DATE: 3-28-18

APPLIES TO: This service bulletin applies to 2010 through 2018 model year MM and K2 model motor home chassis built between April 2, 2009 through April 19, 2017.

CONDITION: Spring washers may be subject to cracking

FIG. 2-1

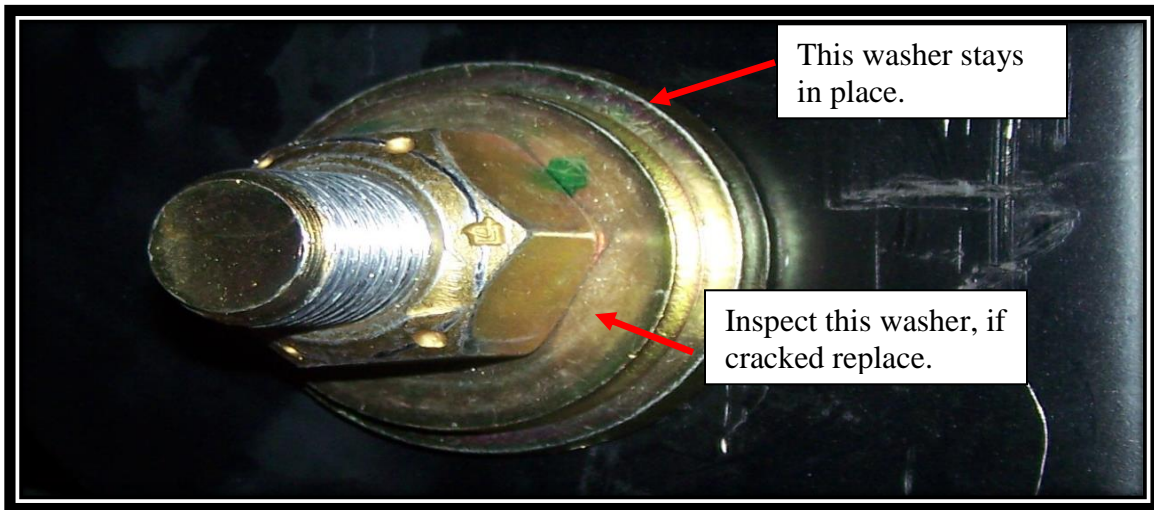
1. Follow normal maintenance and safety procedures to gain access to the front hangers. **Note: Dis-assemble and re-assemble one side at a time.** Tires do not need to be off ground.
2. On the left side (Drivers) inspect the spring washer, if cracked remove nut and replace spring washer with crown out towards nut. Re-install the nut and torque to 525 lbf-ft. Refer to FIG. 2-1.

FIG. 2-2

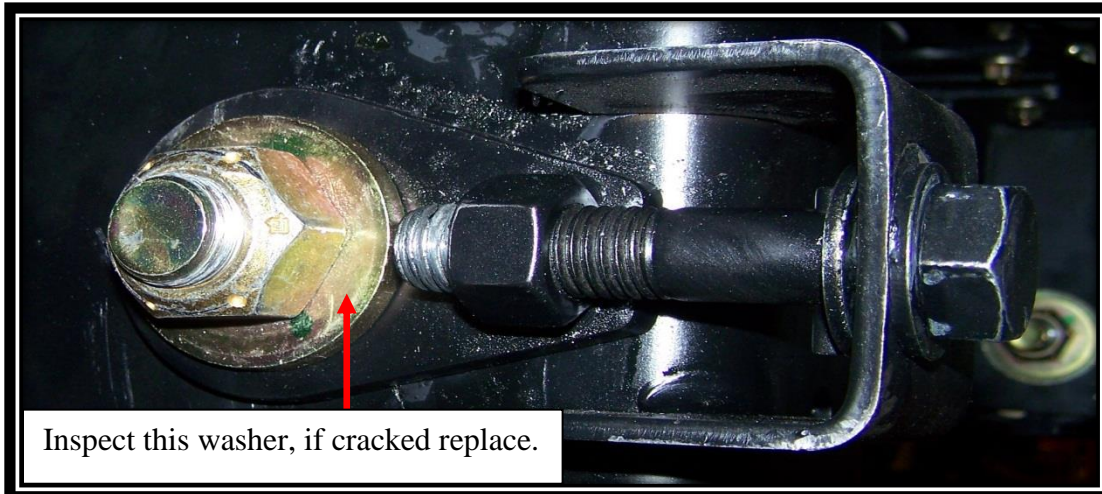
3. On right side (passenger) shown below, inspect spring washer, if cracked remove nut and replace spring washer with crown out towards nut. Re-install nut and torque to 525 lbf-ft. Refer to FIG. 2-2.
